ORIGINATION FORM

Proposed Revisions to a Standard Plans Index
(Please provide all information — Incomplete forms will be returned)

Index Number: 430-040
Sheet Number (s): 1 and 2 of 2
Index Title: Winged Concrete Endwalls

TABLE OF CONTENTS:	
Sheet	Description
1	General Notes and Contents
2	U-Type and 45° Endwalls

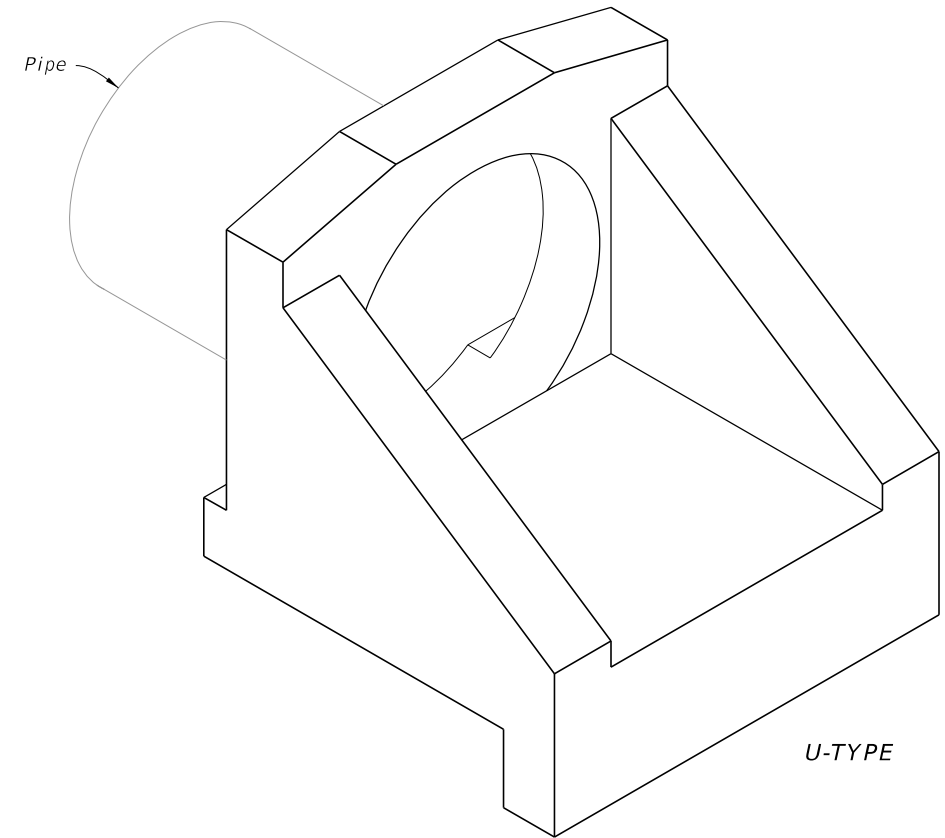
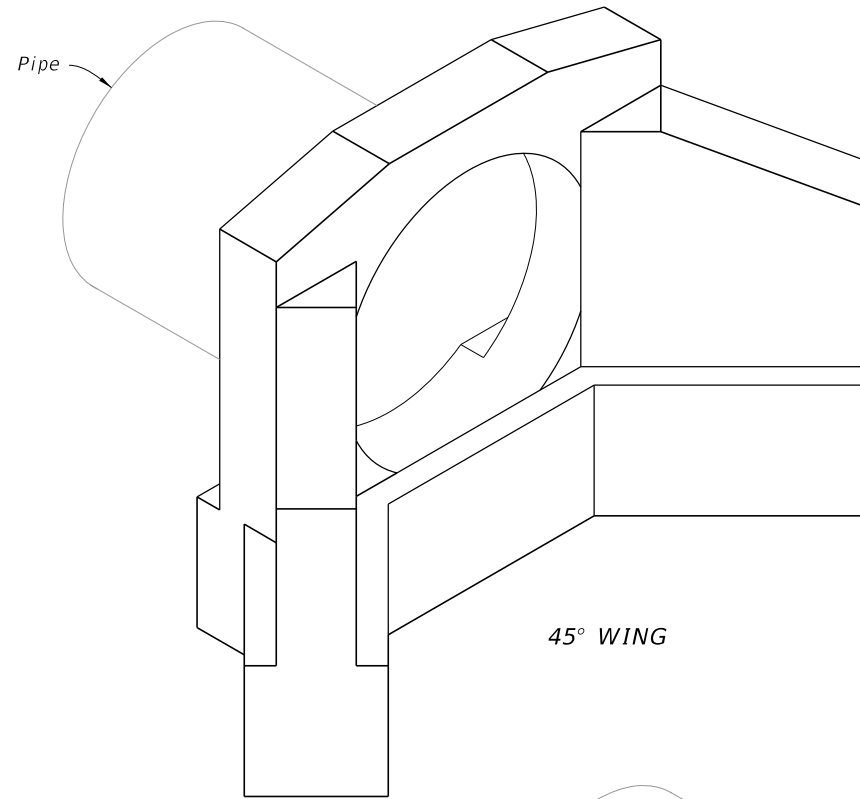
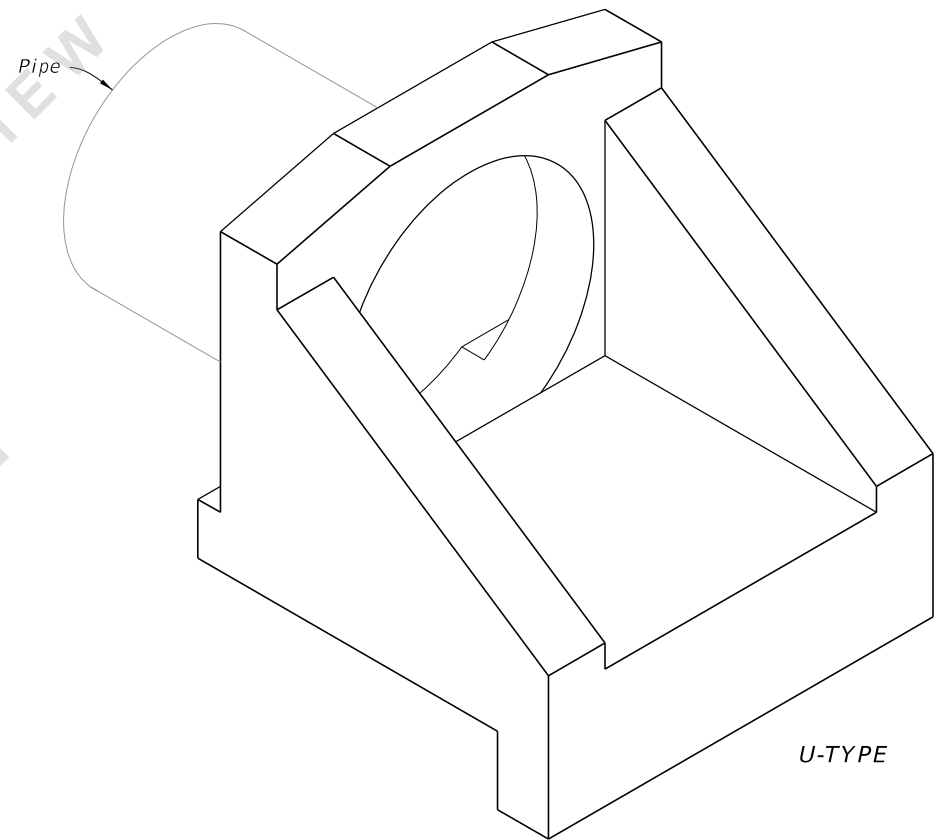
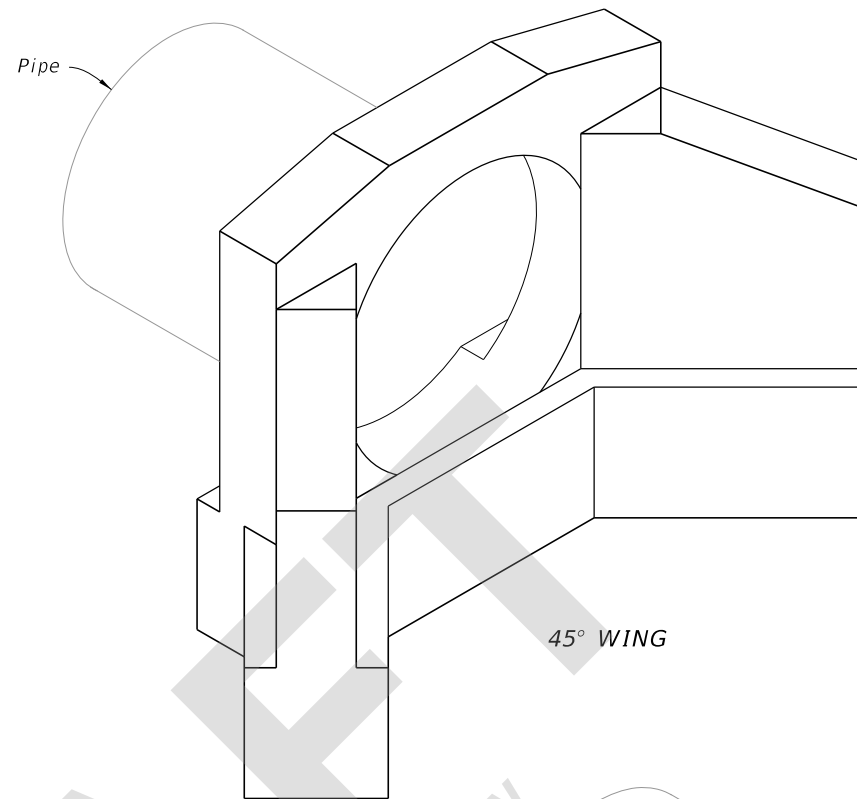
Sheet 1: Changed GENERAL NOTE 1 from "Class I" to "Class II".

1. Use Class I concrete. ← **CHANGED TO: Class II**
2. Chamfer all exposed edges and corners $\frac{3}{4}$ " unless otherwise shown.
3. Quantities shown are for estimating purposes only.

1. Use Class II concrete.
2. Chamfer all exposed edges and corners $\frac{3}{4}$ " unless otherwise shown.
3. Quantities shown are for estimating purposes only.

U-TYPE AND 45° ENDWALLS

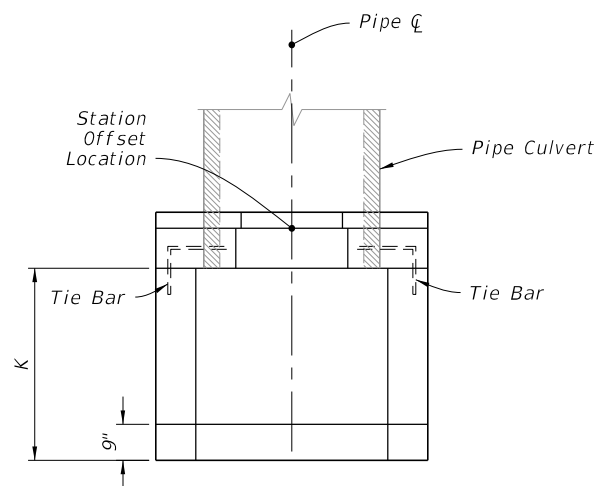
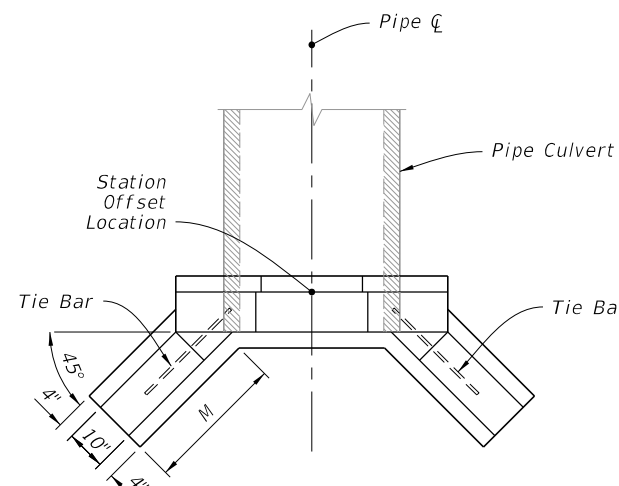
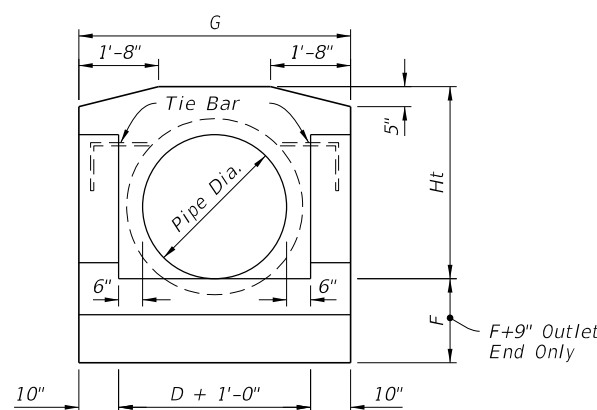
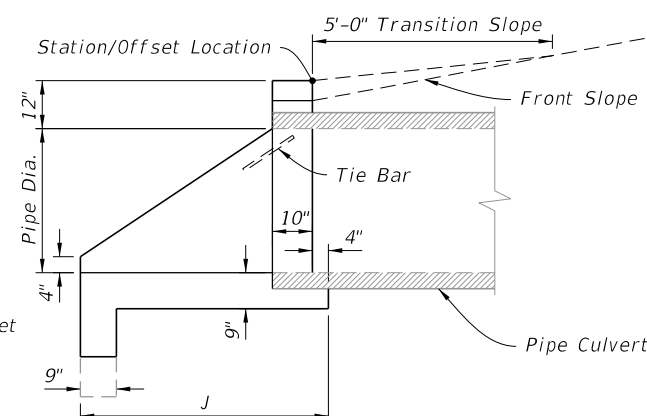
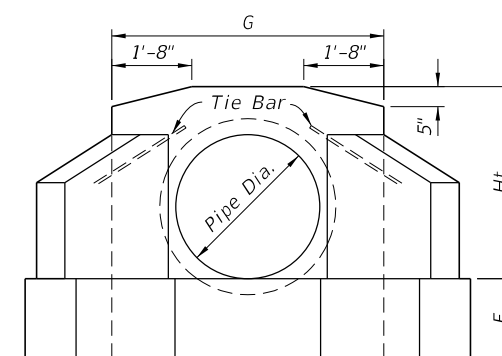
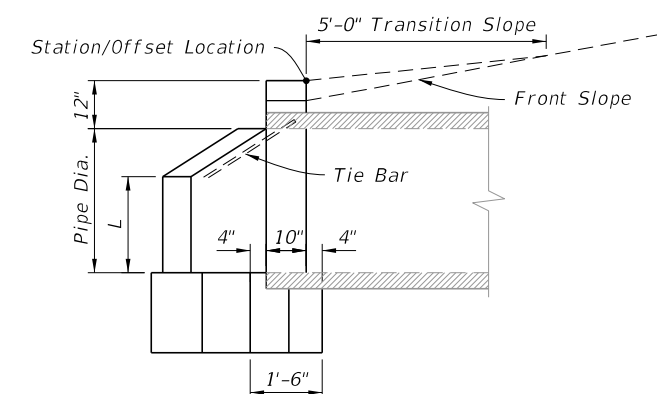
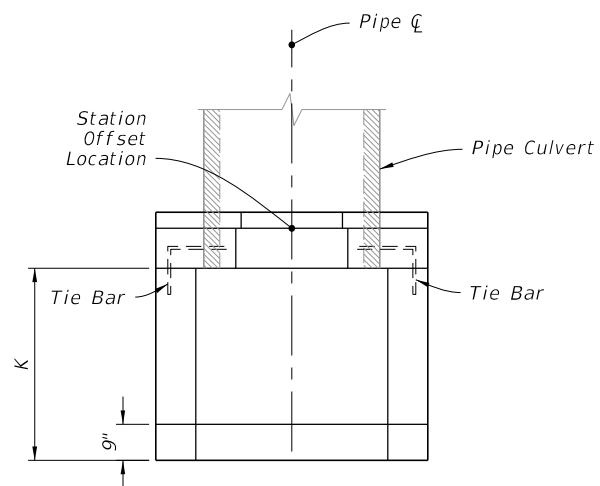
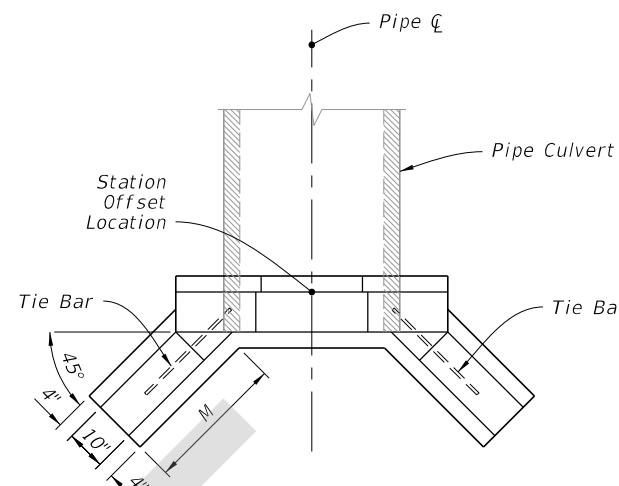
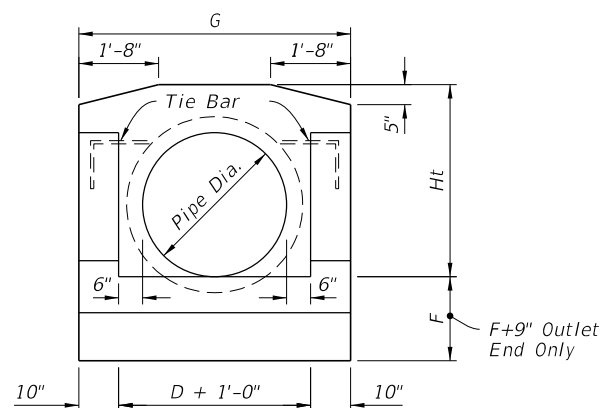
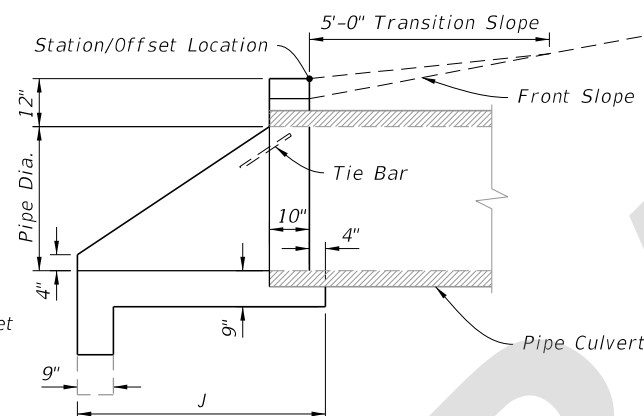
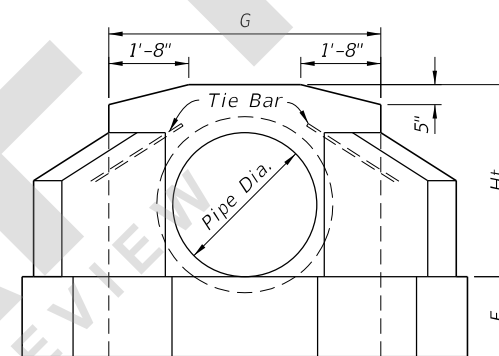
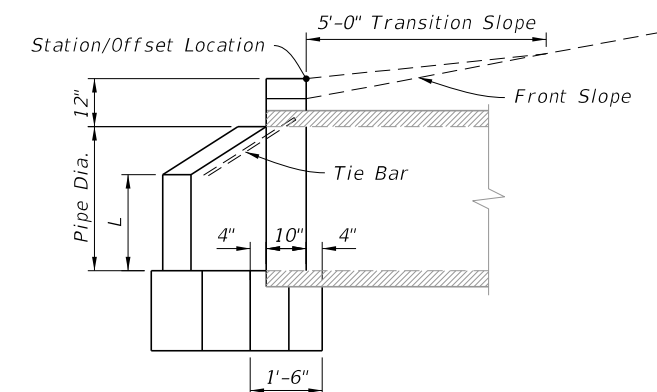
Sheet 2: Changed "Class I" to "Class II" in the DIMENSION AND ESTIMATED QUANTITIES TABLES.

CHANGED TO: Class II

DIMENSIONS AND ESTIMATED QUANTITIES PIPE CULVERT ENDWALLS WITH U-TYPE WINGS													
DIMENSIONS							QUANTITIES IN ONE ENDWALL						
Pipe		Wall			Footing		Concrete, Class II, Total (CY)						Steel Tie Bars
Dia. D	Area (ft ²)	G	Ht	K	F	J	RCP		CMP		CIP		
							Inlet	Outlet	Inlet	Outlet	Inlet	Outlet	
15"	1.2	3'-11"	2'-3"	1'-5"	1'-3"	2'-7"	0.59	0.67	0.62	0.70	0.61	0.70	none
18"	1.8	4'-2"	2'-6"	1'-9"	1'-3"	2'-11"	0.70	0.79	0.74	0.82	0.74	0.82	none
24"	3.1	4'-8"	3'-0"	2'-6"	1'-6"	3'-8"	1.01	1.11	1.06	1.16	1.06	1.16	2-#6 Bars x 2'-0"
30"	4.9	5'-2"	3'-6"	3'-3"	1'-6"	4'-5"	1.33	1.44	1.41	1.51	1.40	1.51	2-#6 Bars x 2'-0"
36"	7.1	5'-8"	4'-0"	4'-0"	1'-9"	5'-2"	1.73	1.85	1.84	1.96	1.82	1.94	2-#6 Bars x 2'-6"
42"	9.6	6'-2"	4'-6"	4'-9"	2'-0"	5'-11"	2.19	2.32	2.32	2.45			2-#6 Bars x 2'-6"
48"	12.6	6'-8"	5'-0"	5'-6"	2'-0"	6'-8"	2.64	2.78	2.81	2.95			2-#6 Bars x 3'-0"

DIMENSIONS AND ESTIMATED QUANTITIES PIPE CULVERT ENDWALLS WITH 45° WINGS											
DIMENSIONS							QUANTITIES IN ONE ENDWALL				
Pipe		Wall			Footing	Concrete, Class II					Steel Tie Bars
Dia. D	Area (ft ²)	Ht	G	L	M	F	Total (CY)				
							RCP	CMP	CIP		
15"	1.2	2'-3"	3'-7"	1'-0"	1'-3"	1'-3"	0.56	0.59	0.59	none	
18"	1.8	2'-6"	3'-10"	1'-2"	1'-7"	1'-3"	0.74	0.77	0.77	none	
24"	3.1	3'-0"	4'-4"	1'-5"	2'-1"	1'-4"	1.01	1.06	1.06	2-#6 Bars x 2'-0"	
30"	4.9	3'-6"	4'-10"	1'-9"	2'-5"	1'-6"	1.32	1.40	1.39	2-#6 Bars x 2'-0"	
36"	7.1	4'-0"	5'-4"	2'-0"	2'-11"	1'-8"	1.72	1.83	1.82	2-#6 Bars x 2'-6"	
42"	9.6	4'-6"	5'-10"	2'-3"	3'-6"	2'-0"	2.34	2.47		2-#6 Bars x 2'-6"	
48"	12.6	5'-0"	6'-4"	2'-6"	4'-0"	2'-0"	2.74	2.90		2-#6 Bars x 2'-6"
